To: Plan Holders for Improvements to the
Monett Regional Airport
Pierce City, Missouri
Project No. 20-098B-1

Schedule I – Earthwork and Grading for Relocation of Runway 18/36

**ADDENDUM NO. 4
TO
CONTRACT DOCUMENTS, SPECIFICATIONS AND PLANS
FOR IMPROVEMENTS TO THE
MONETT REGIONAL AIRPORT
PIERCE CITY, MISSOURI
PROJECT NO. 20-098B-1**

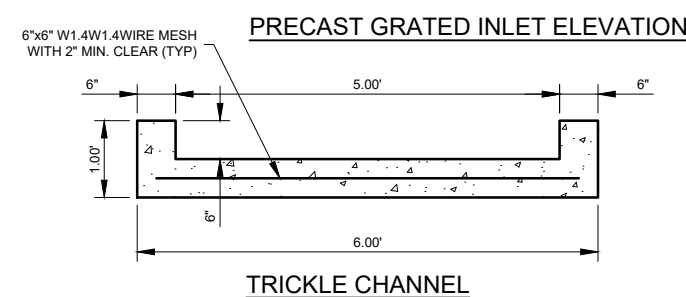
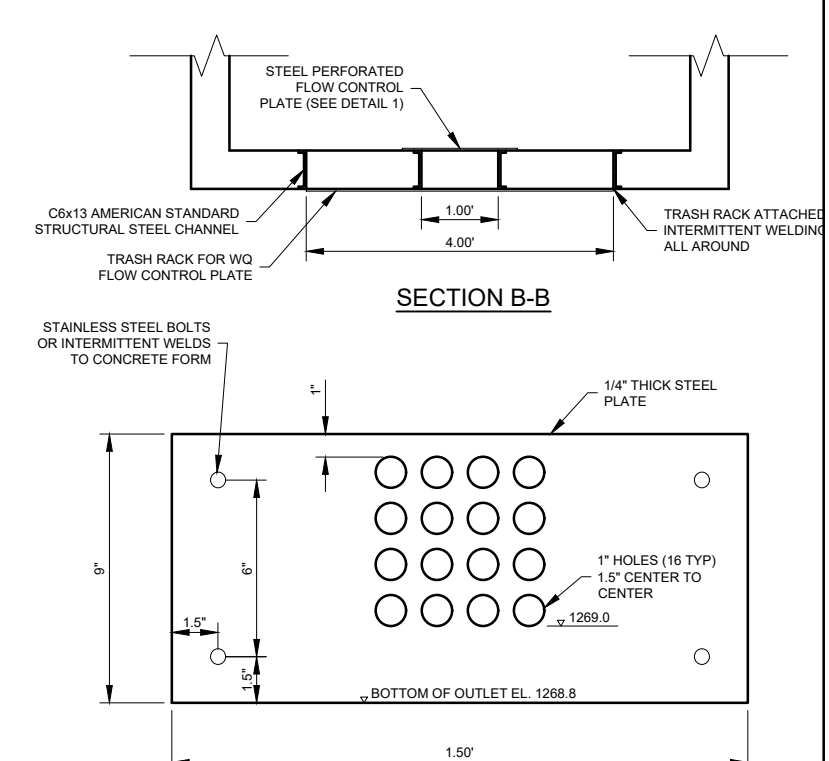
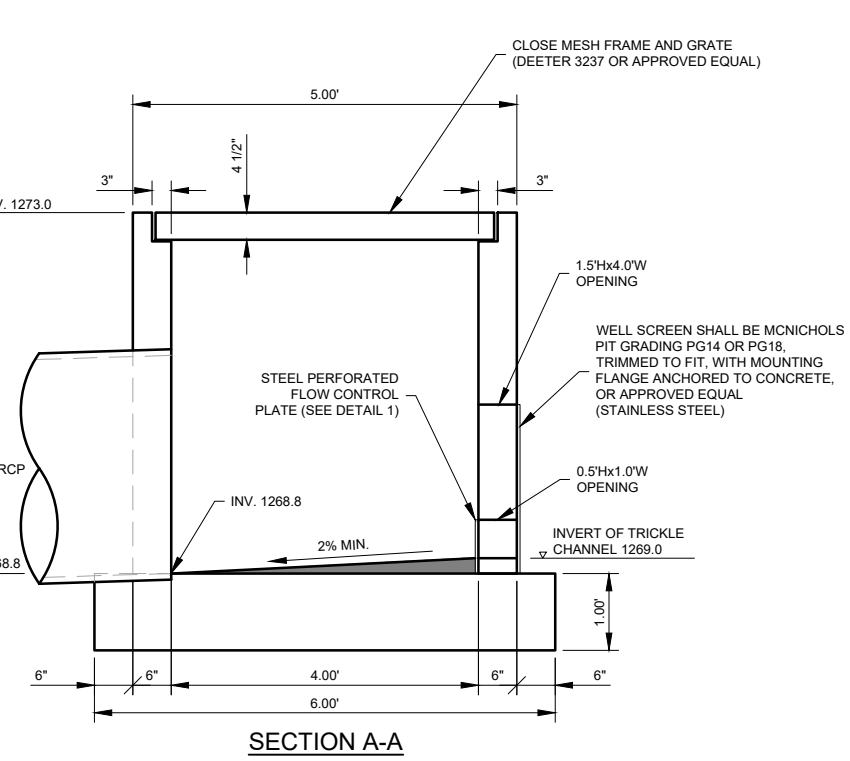
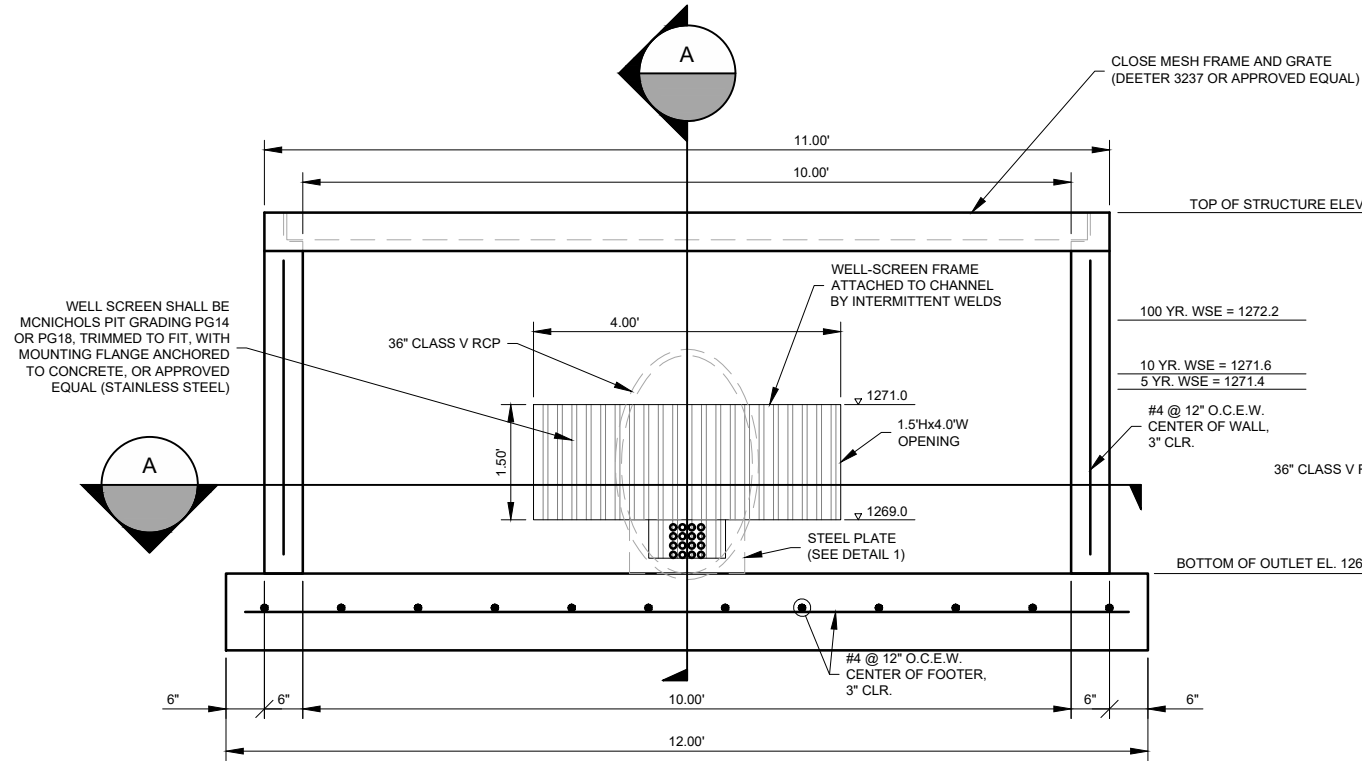
- a. Yes, see revised sheets C650-C652, attached.
20. The outlet control structure for Det. Pond "B" shows a rim elevation of 1271 (same as Pond "J"), but the spillway is 1263. Is this intentional?

- a. Correct, Pond B vertical information was incorrect, see revised sheet C651, attached.
21. Detail for inlet structure appears to indicate some sump below FL out prior to pouring invert, but no dimension is given.

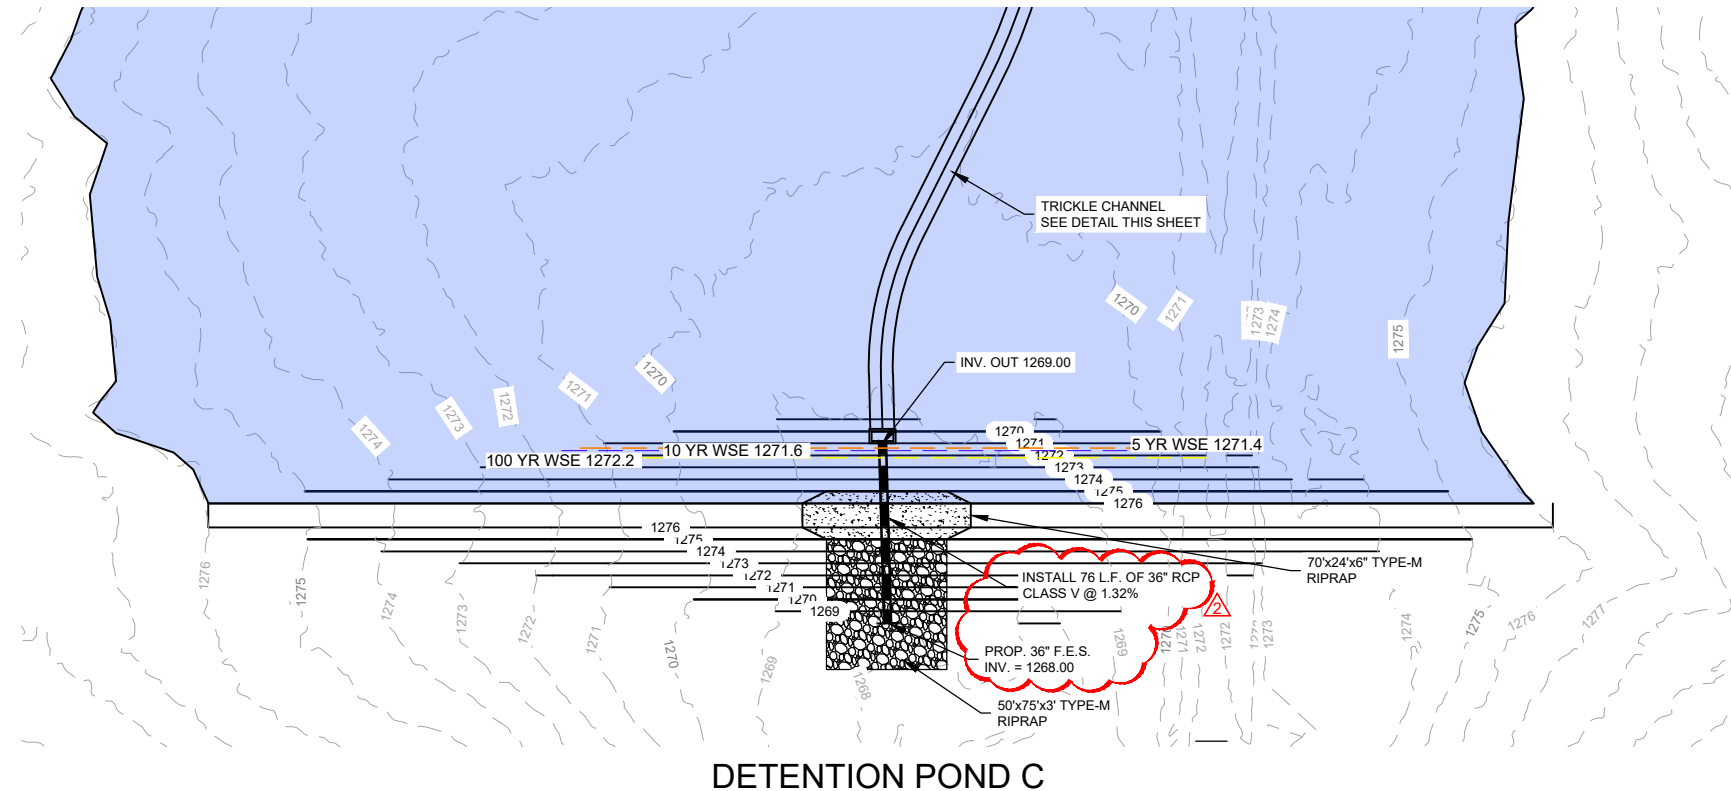
Sheets: C650-C652

Title: Detention Pond Outlet Structure

Revision: Updated plan to show pipe and FES size and updated elevation requirements on Pond B.
